Data Centre

43-61 Turner Road,
Gregory Hills,
New South Wales, 2557.

SSDA Accessibility Report

2 October 2024
Obvius Access Consultants
For Greenbox

Figure 1 showing Man trap portal.

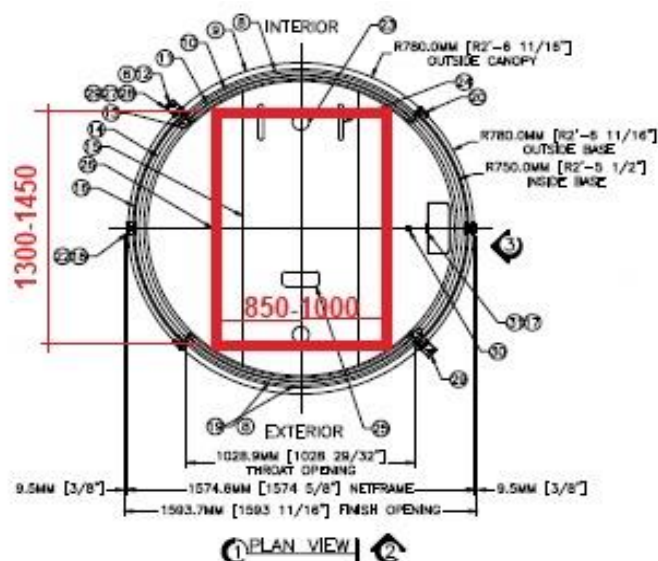
A Man Trap Portal or alternative accessible entry point at the security location between the entrance lobby and the building front of house (FOH) secure areas must meet the intent of the Disability Discrimination Act 1992.

In accordance with AS1428.1:2009 Clause 6.1 revolving doors or turnstiles are not a continuous accessible path of travel. Therefore, provide an accessible door adjacent to a revolving door or turnstile that complies with the door circulation requirements of AS1428.1:2009 Clause 13.3 figure 31.

Where Man Trap Portals are provided at least one small room/vestibule designed to trap those who would enter a secure area of the facility should be accessible for a person with a disability. Accordingly, the Man Trap Portal should also allow for an individual to access and exit in the instance of an emergency to the non-secure area, or to use the designated ground floor unisex accessible toilet when provided in the entrance lobby area.

The Man Trap Portal or alternative accessible entry point must comply in accordance with AS1428.1:2009 and must be built of sufficient size of at least a clear 850mm, (1000mm preferred clear width through the entry) and 1300mm length (1450mm preferred), which is the footprint of the 90 percentile of wheelchair users in accordance with AS 1428.1:2009. Refer to Figure 1 below.

A Threshold Ramp must be provided at the Man trap Portal, if a threshold exists at the Man trap Portal that exceeds 3mm in height. Accordingly, the threshold Ramp to comply in accordance AS1428 .1:2009 must not exceed a height of 35mm or exceed a length of 280mm or exceed a gradient of 1:8 and be located within 20mm of the door to which it serves.
